[Docket No. FAA–2018–0893; Product Identifier 2018–SW–032–AD; Amendment 39–21319; AD 2020–23–03]

#### Airworthiness Directives; Airbus Helicopters

**ACTION:** Final rule.

#### 2020–23–03 Airbus Helicopters:

Figure 1 to Paragraph (f)(1)

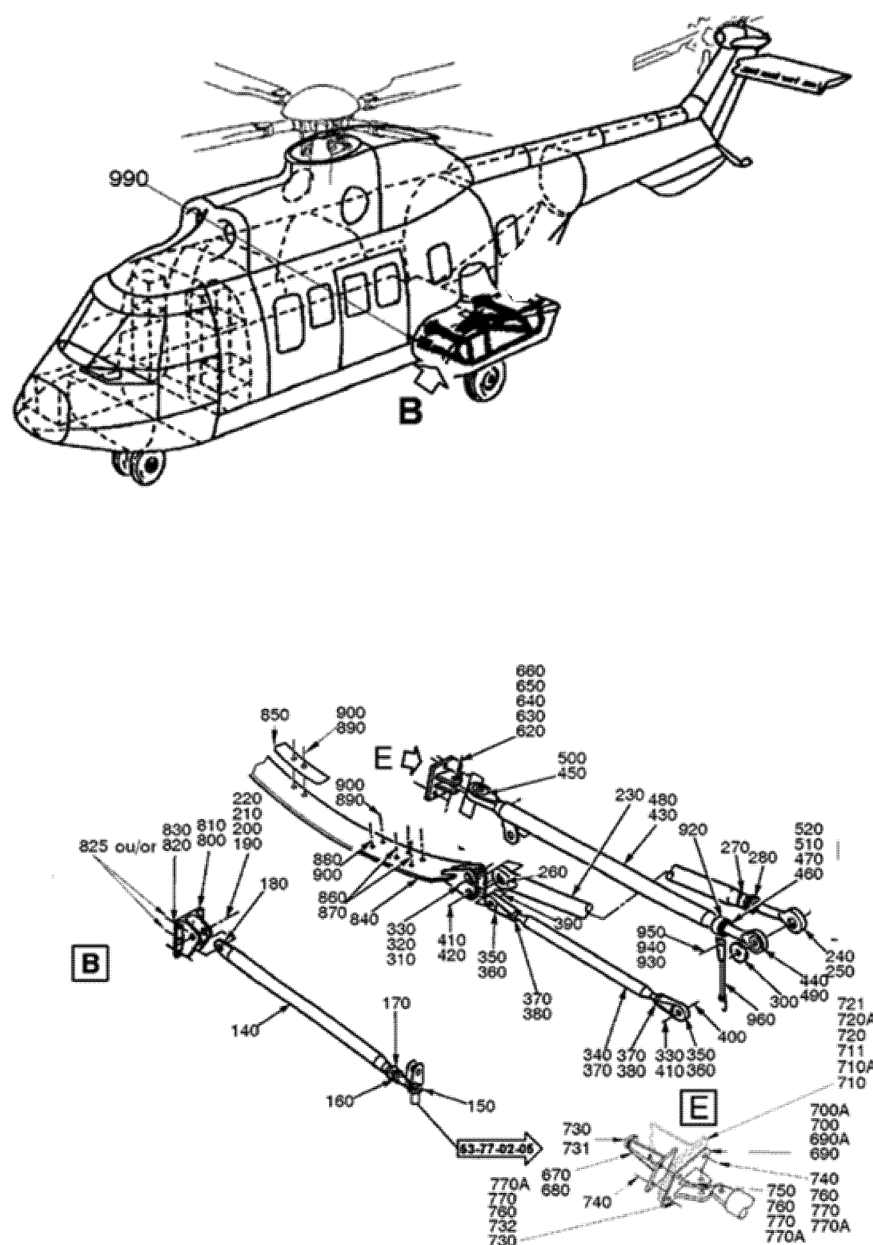
(1) Within 15 hours time-in-service (TIS), and before each flight over water thereafter, visually check each emergency flotation gear left hand (LH) and right hand (RH) rear upper fitting to determine whether the heads of the lower screws are present. Figure 1 to paragraph (f)(1) of this AD depicts where the lower three screws (noted as B and E) are located. Check each screw for looseness by determining whether it can be rotated by hand. These actions may be performed by the owner/operator (pilot) holding at least a private pilot certificate and must be entered into the aircraft records showing compliance with this AD in accordance with 14 CFR 43.9(a)(1) through (4) and 14 CFR 91.417(a)(2)(v). The record must be maintained as required by 14 CFR 91.417, 121.380, or 135.439.

(2) If a screw head is missing, or if a screw is loose, before further flight over water, install MOD 0728456 by completing paragraph (f)(3) of this AD.

(3) Within 300 hours TIS, unless required before further flight over water by paragraph (f)(2) of this AD, install MOD 0728456 by doing the following:
